# Work Order ID 62039

Item Name: Crosstube Low Standard Aft

| DRAWING NO.<br>D412-664-249 | TITLE<br>CROSSTUBE ASS'Y (412 LOW AFT) | REV. B                  | DART AEROSPACE LTD<br>ENGINEERING ORDER |  | D.E.O. NO.<br>D412-664-249-B-1 | SHEET NO.<br>SHEET 1 OF 2 | SCALE<br>NTS |

**D412-664-249  
ASSEMBLY DETAIL**

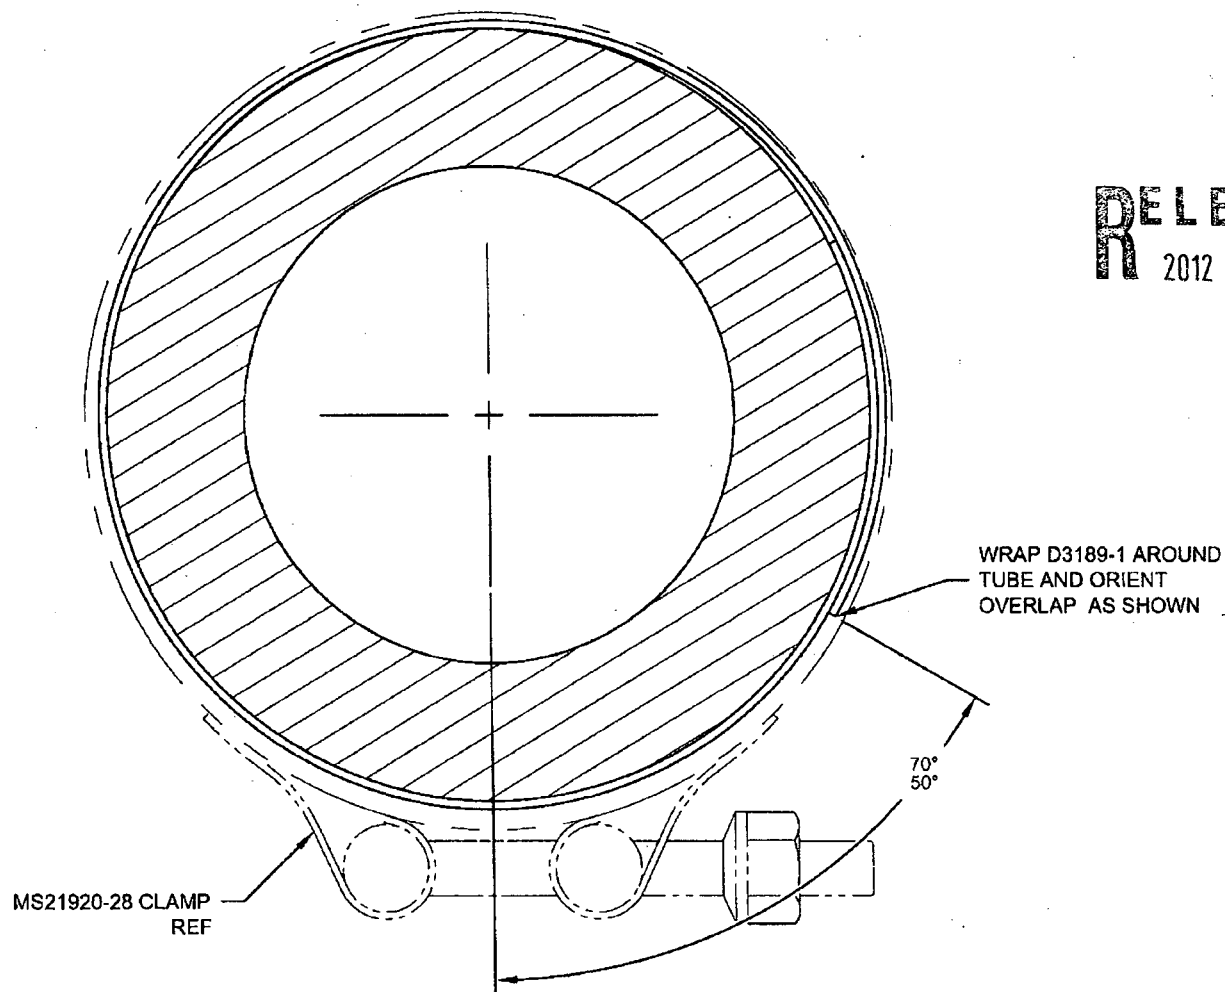
**NOTE 14 AND 16 ON SHEET 1 IS AMENDED AS FOLLOWS:**

14 16  
D2856-600-1009 ABRASION STRIP  
D3189-1 CHAFING SHIELD (1, INSTALLED OVER ABRASION STRIP)  
MS21920-28 CLAMP, 2X  
2 PL
